March 26, 2013

Re: Response to your letter of September 24, 2012 regarding the renewal of CCPCUA Permit No. CU3148, Martin Marietta Materials Vanceboro Quarry.

FIGURE 1

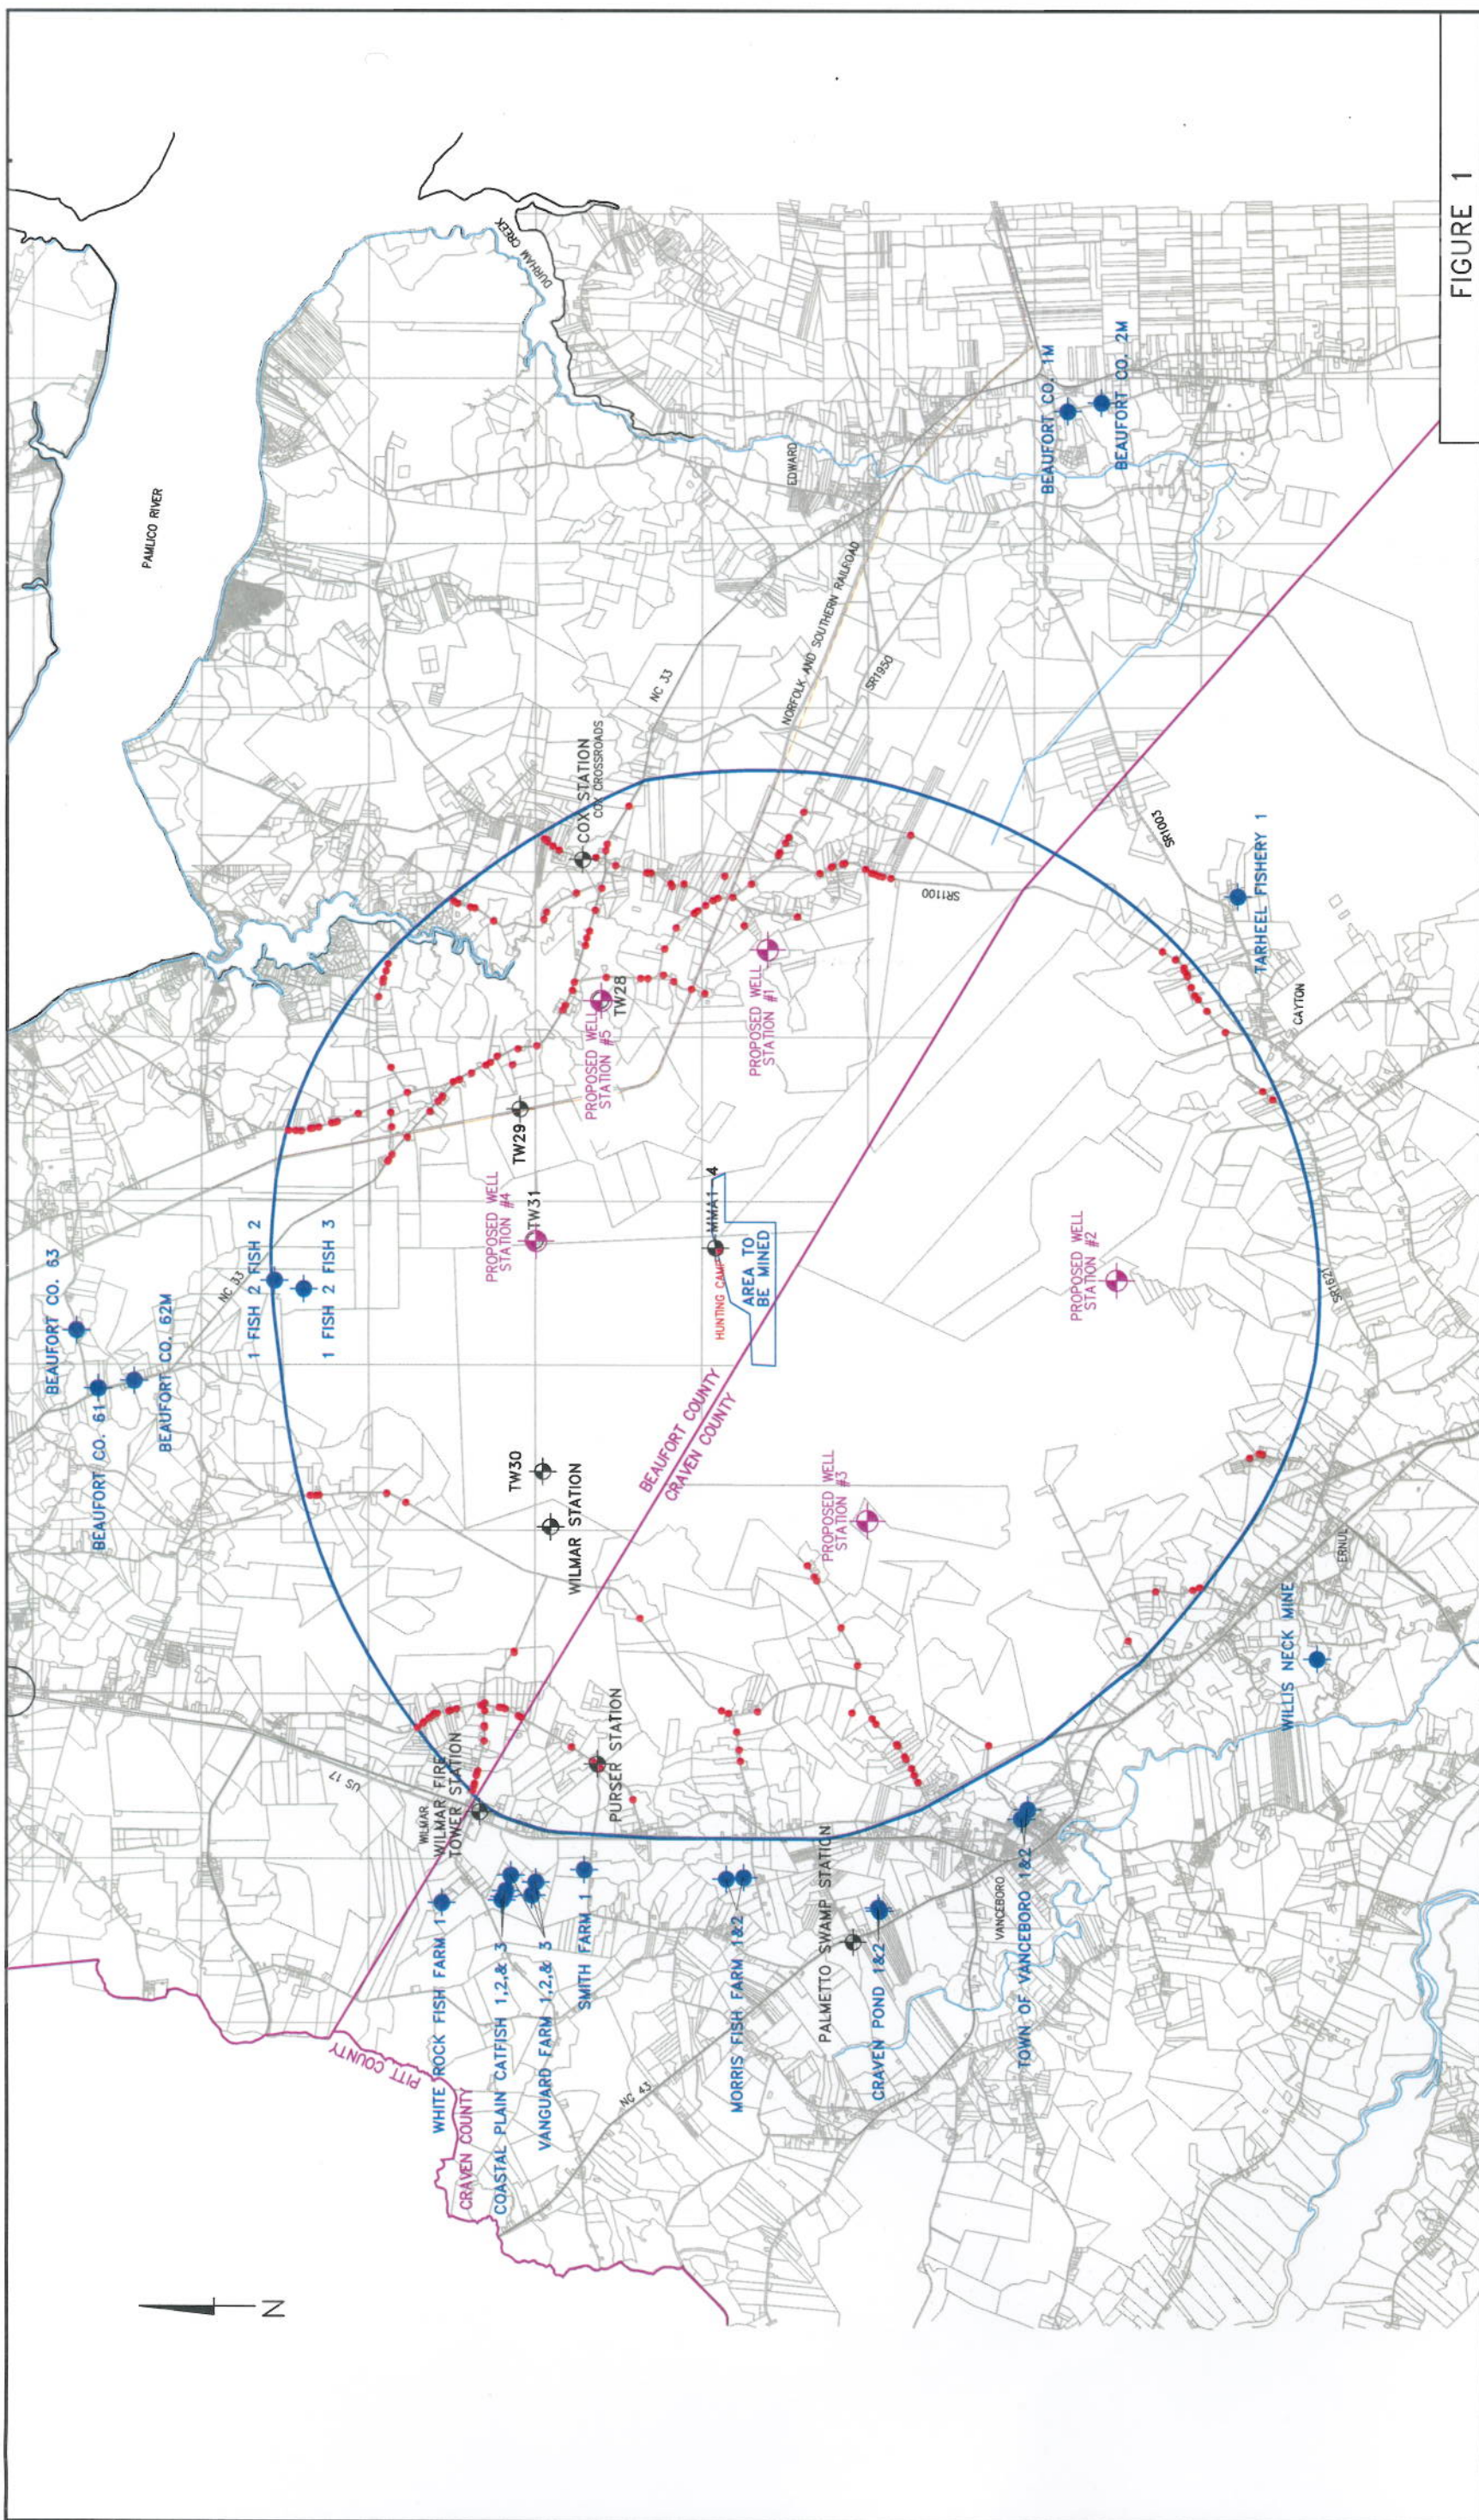
- 3) *"NCDWR feels it is important to have a more complete monitoring well network to track the cone of depression once the mine becomes active."* NCDWR provided Martin Marietta Materials with a map that marked positions of 7 monitoring stations where NCDWR requested clusters of monitoring wells should be installed. At the January 13, 2013 meeting, we discussed the purpose of each monitoring station, and we developed alternative locations and numbers of monitoring wells to be constructed to meet the needs of NCDWR's requested monitoring system. Agreement was reached on reducing the number of stations from 7 to 5. Stations numbered #2 and #3 will remain as originally proposed while stations #4 and #7 will be deleted. The location of stations #1, #5, and #6 will be modified as described below to minimize well construction efforts and costs.

Station #1 – The original location of proposed monitoring Station #1 was on the county line approximately 4 miles from the center of the proposed mine. We discussed moving Station #1 to a position about 7500 feet to the north of the original planned location. With this new position of the proposed monitoring station, we were able to eliminate the need for NCDWR's requested Station #7. We decided to focus our monitoring in areas closer to the mine to determine if the cone of depression expands in a manner consistent with the computer modeling performed for the site. Likewise, we agreed to eliminate Station #4 due to its distance from the mine. During the initiation of mining and associated dewatering, Martin Marietta Materials will closely monitor the water level response in the nearby monitoring stations to determine if the cone of depression is consistent with the model predictions. If it is determined that the cone of depression is expanding significantly more than the model predictions, then Martin Marietta

NCDWR Proposed Station #5 – In order to make best use of existing monitoring wells, Martin Marietta Materials proposed to move Station #5 to a position beside TW-31. The intent will be to investigate (video log) the casing depth of TW-31, and then convert TW-31 to a Lower Castle Hayne monitoring well by installing a screened liner that discretely monitors a specific (up to 20 feet) section of the Lower Castle Hayne aquifer. Two additional monitoring wells will be constructed next to TW-31, one open to the Upper Castle Hayne and the other open to the Surficial Aquifer. In doing this, Martin Marietta can minimize the amount of drilling required to construct monitoring well Station #5. When constructed, this station would be renamed Station #4.

NCDWR Proposed Station #6 – NCDWR had requested that a monitoring well station be constructed to the east of the proposed mine. After further discussion, we agreed to move the monitoring station to the TW-28 site. TW-28 will be converted into a Lower Castle Hayne monitoring well (with a screened liner that includes not more than 20 feet of screen). Then, an Upper Castle Hayne monitoring well and a Surficial Aquifer well will be constructed beside TW-28. This approach will help to minimize the amount of drilling required to construct Station #6. Station #6 would be renamed Station #5. The plan for modifying TW-28 is based upon the assumption that PCS Phosphate Company provides permission to Martin Marietta Materials to modify the well and use the well for future monitoring.

The attached Figure 1 illustrates the locations of the five monitoring well stations proposed to be installed. Martin Marietta Materials plans to construct the monitoring well system at least 6 months prior to beginning dewatering operations to support the mine. The intent is to obtain baseline (pre-mine) water-level data from each monitoring well for a period of at least 6 months before mine dewatering commences. NCDWR agreed to this intended schedule.

FIGURE 2

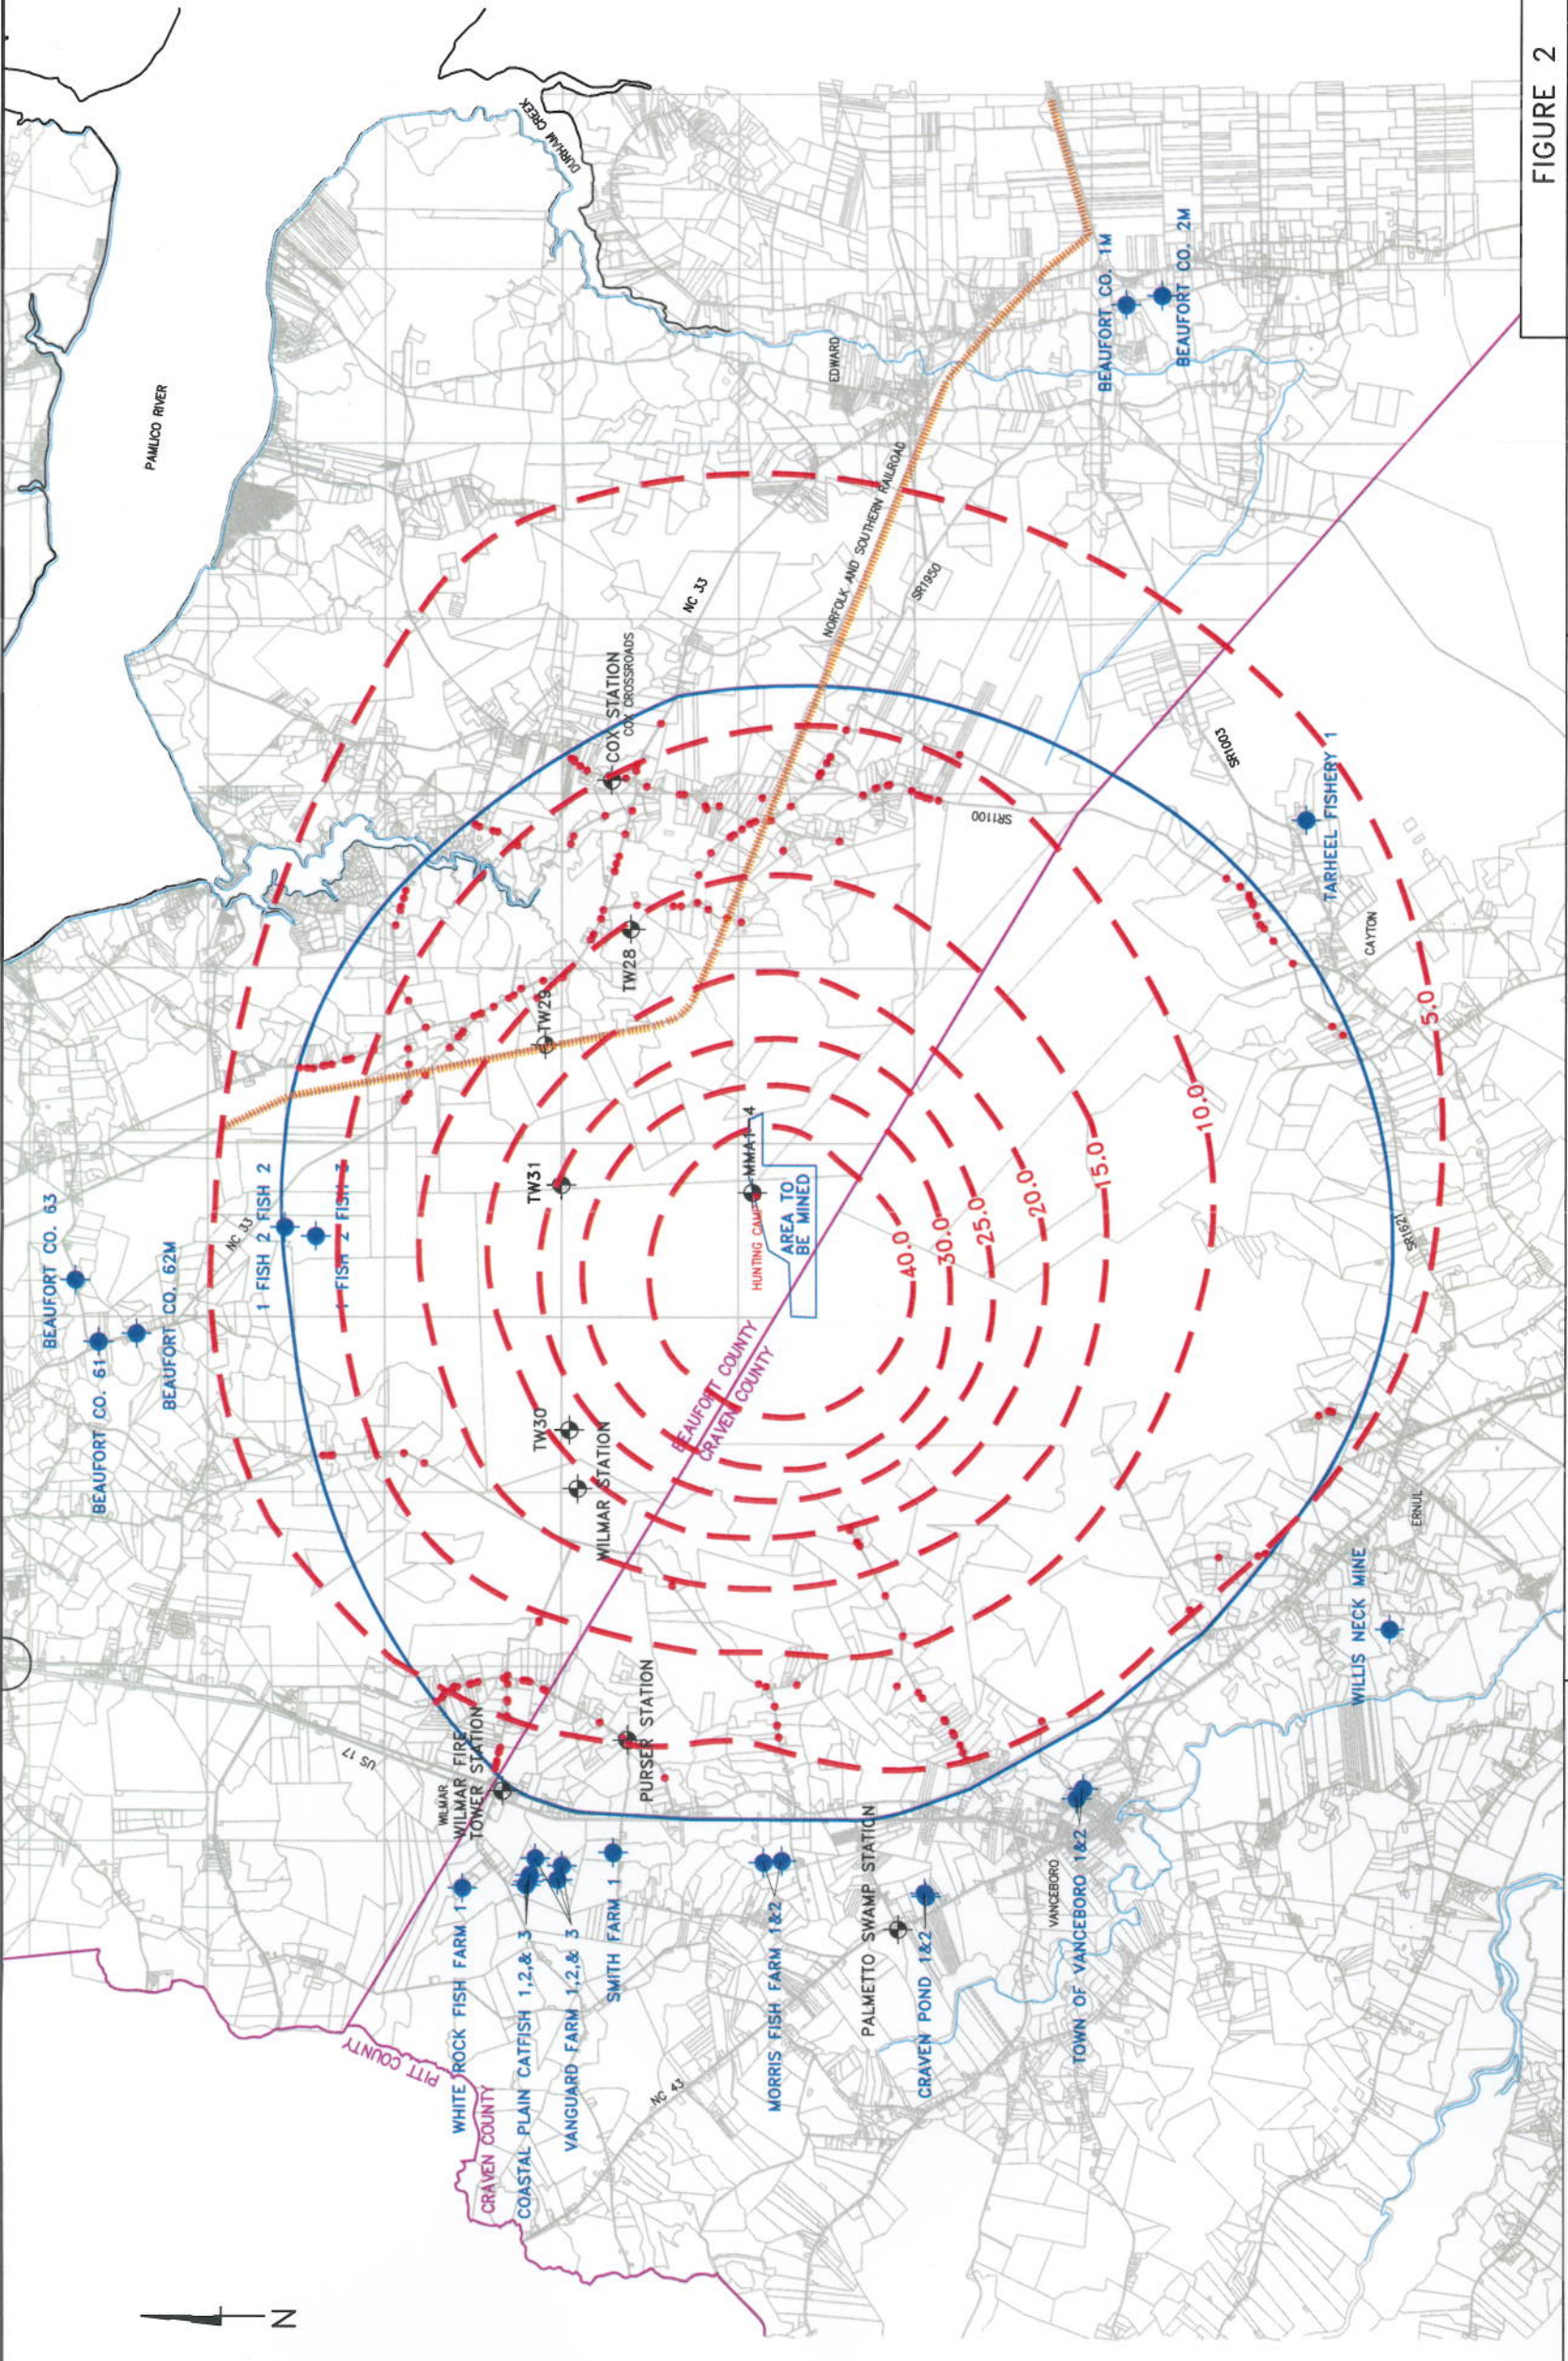
- 5) "Please provide a map of the predicted cone of depression showing 5 ft interval contours from the pit out to the 5 ft drawdown contour in a map similar to Figure 6 in GMA's June 15, 2010 report which contains existing groundwater users and proposed monitoring sites". GMA prepared an updated draft map depicting drawdown contours as requested. The drawdown contours are at 5 feet intervals to 30 feet of drawdown, and then we depict the 40 feet drawdown contour. Additional drawdown contours greater than 40 feet were not depicted due to the closeness of contours that would be necessary near the proposed pit. NCDWR stated that the draft map was acceptable to meet their request. Therefore, GMA has prepared a final version of the requested drawdown map, and the map is included with this letter as Figure 2.
